**Subject: Submittal of Response to NRC Request Related to ESBWR Design Certification Application Chapter 18 - Human Factors Engineering - RAI Number 18.8-47 S02**

**Submittal of Response to NRC Request Related to  
ESBWR Design Certification Application Chapter 18  
Human Factors Engineering  
RAI Number  
18.8-47 S02**

## **NRC RAI 18.8-47 S02**

### ESBWR Minimum Inventory Development Process

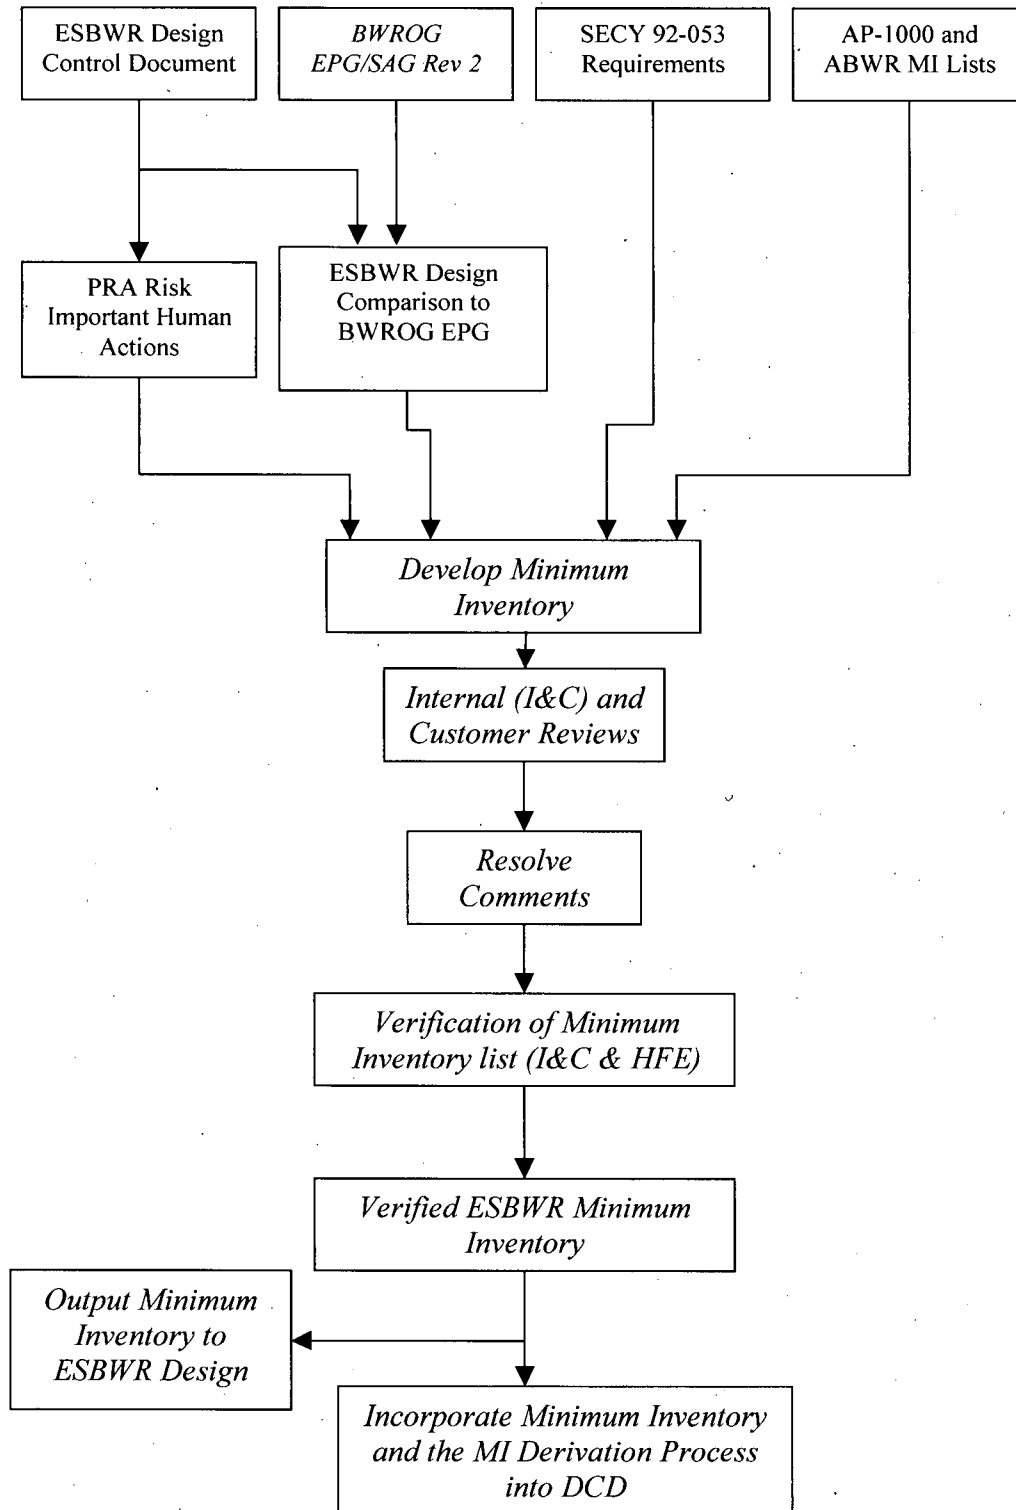
*The response states that no changes will be made to the NEDO. However, the NEDO does not currently contain all the information requested by the RAI. The NEDO should be updated to incorporate this information.*

During the task analysis of the elements described above, minimum inventory HSIs are designated if they meet the following selection criteria:

- HSIs that provide for the performance of safety-related functions to respond to design basis events for which there is no automatic control (Corresponds to RG 1.97 variable selection criteria)
- HSIs that provide for assessing, accomplishing, or maintaining critical safety functions and safe shutdown conditions (Corresponds to RG 1.97 variable selection criteria)
- HSIs that provide for the performance of risk important human actions as identified in the ESBWR PRA
- HSIs that provide dedicated safety system actuation such as reactor scram, MSIV isolation, and ATWS response initiation

ESBWR minimum inventory HSIs are documented in a table that lists the parameter and whether the associated HSI consists of an alarm, display, and/or control.
